**TOWN OF NEWBURGH
PLANNING BOARD
TECHNICAL REVIEW COMMENTS**

PROJECT NAME: MKJC REALTY, LLC
PROJECT NO.: 2023-11
PROJECT LOCATION: SECTION 35, BLOCK 3, LOT 3.22/ NYS ROUTE 32
REVIEW DATE: 27 OCTOBER 2023
MEETING DATE: 2 NOVEMBER 2023
PROJECT REPRESENTATIVE: LANC & TULLY ENGINEERS

Re: Site Plan for MKJC Realty LLC
SBL: 35-3-3.22
Planning Board # 2023-11

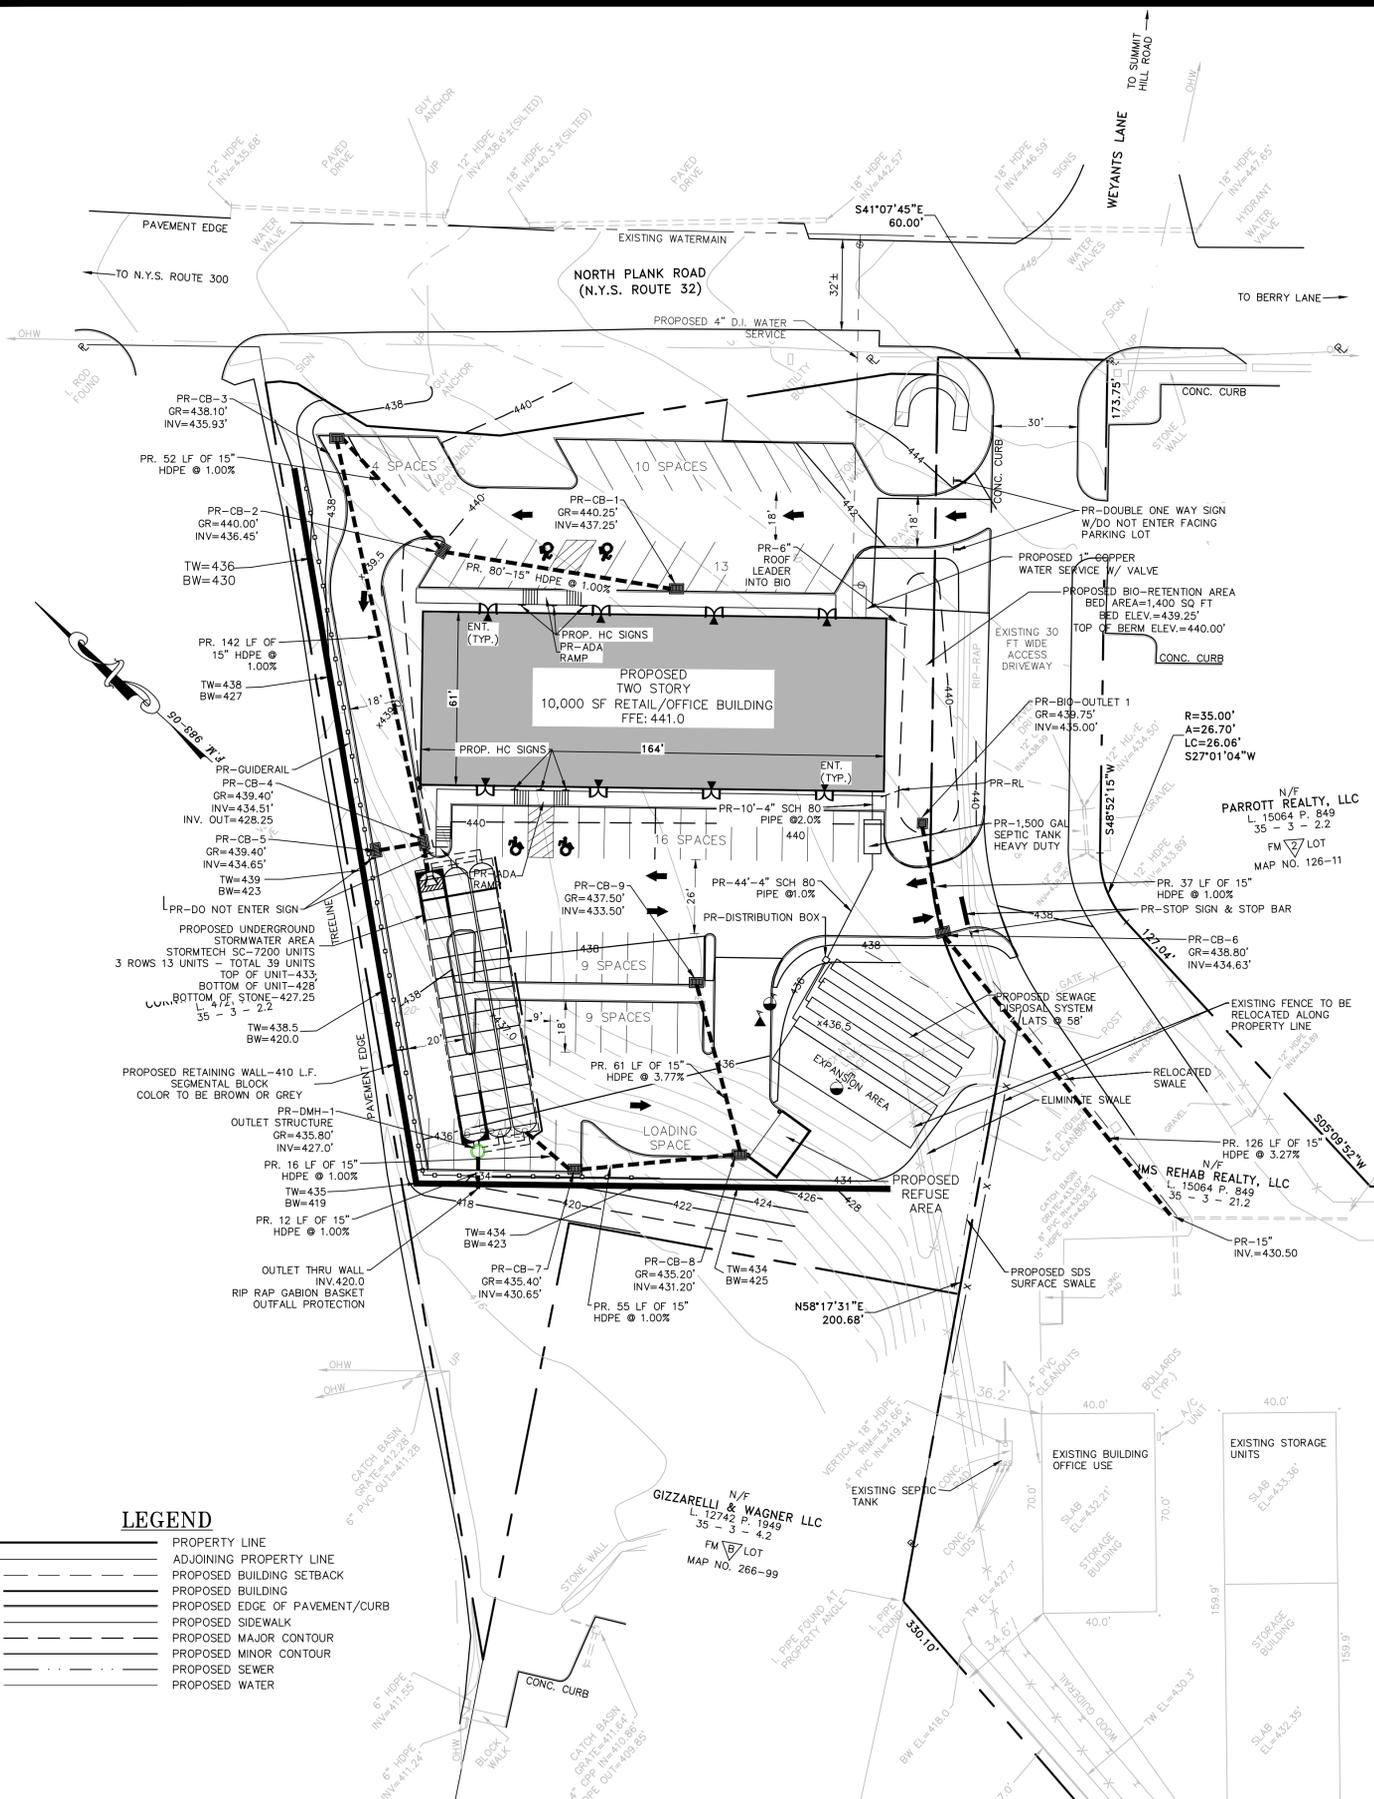
1. The Tree Removal Plan should be modified to identify each of the three classes of trees in the Town Tree Preservation Code. It appears that only a limited number of the trees on the site would be considered under the Tree Code based on diameter.

8. The Tree Preservation Plan should identify the percentage of trees to be removed. Species of trees should be identified in the Tree Preservation Plan. It appears that only one tree greater than 20 inches is proposed to be removed.

13. Please note that currently the tree location and removal plan does not list the species of each tree nor the apparent condition of the tree. The list also includes trees with a DBH of 8" or greater. The chart should only show trees with a DBH of 10" or greater. The applicant is in the process of having trees identified and the conditions of the trees assessed.

Response: Sheet 3 of the plan set identifies the tree species, number to be removed and the percentage of removal.

Response: The tree location plan has been updated.

SEWAGE DISPOSAL SYSTEM DESIGN
PREPARED FOR

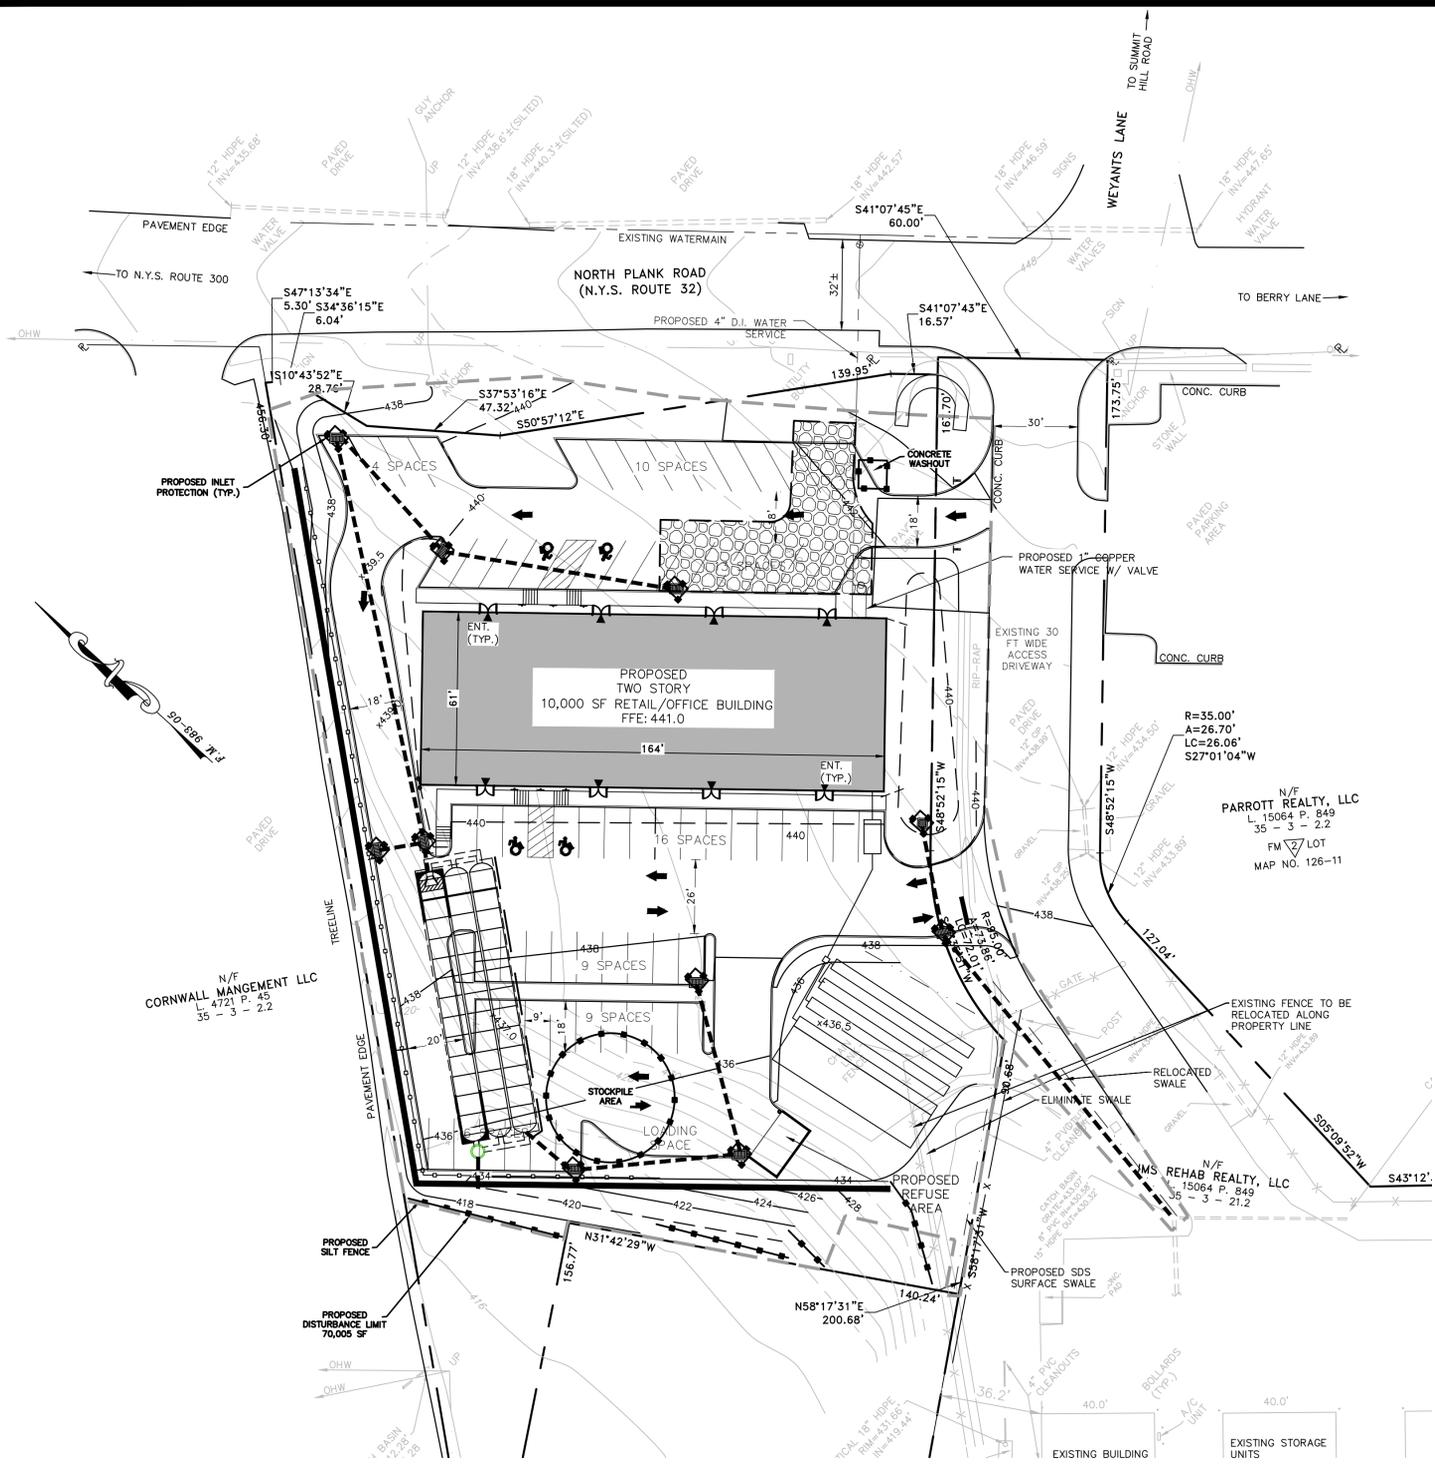
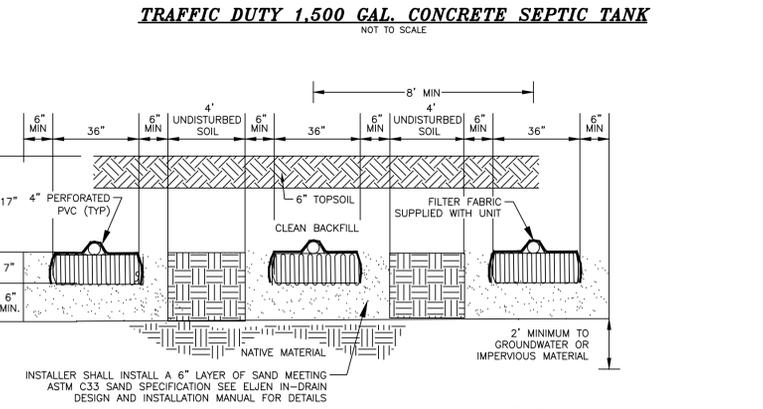
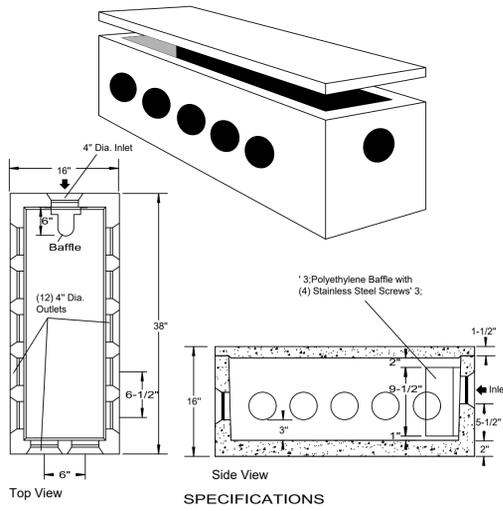
2. Percolation testing for the subsurface sanitary sewer disposal system design is required.\
3. The septic design references a PRESBY System, while the details identify an Elgin Proprietary System. This should be clarified.

4. The sanitary sewer reserve area must be 100% for commercial systems. It appears that the reserve area is 50%.
5. The system design calculations are based on the 10,080 square foot building previously proposed. Building is now 10,000 square feet.

LANDSCAPING DRY-SET STONE RETAINING WALL DETAIL
NOT TO SCALE

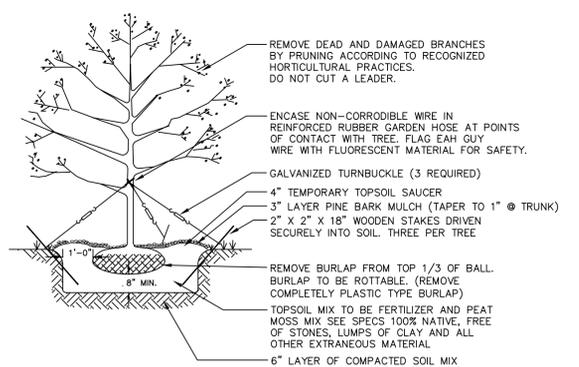
6. This office awaits the submission of a Stormwater Pollution Prevention Plan (SWPPP). The plan is identified to be provided under separate cover.
7. The applicants are proposing a dry-laid stone wall along the entire property frontage to mitigate the parking in front of the structure which is inconsistent with the Town's Design Guidelines. The height of the stone wall is identified as *varies* in the detail. The height of the wall should be identified in the detail.

Response: A stone wall is proposed along the frontage to mitigate the parking area.

ADA AND TYPICAL PARKING SPACE STRIPING DETAIL
NOT TO SCALE

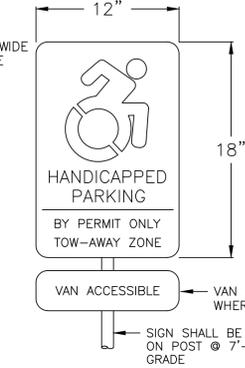
16. Parking lot striping should be consistent with Town of Newburgh requirements utilizing double striping. (Detail Attached)

Response: The striping detail has been updated.
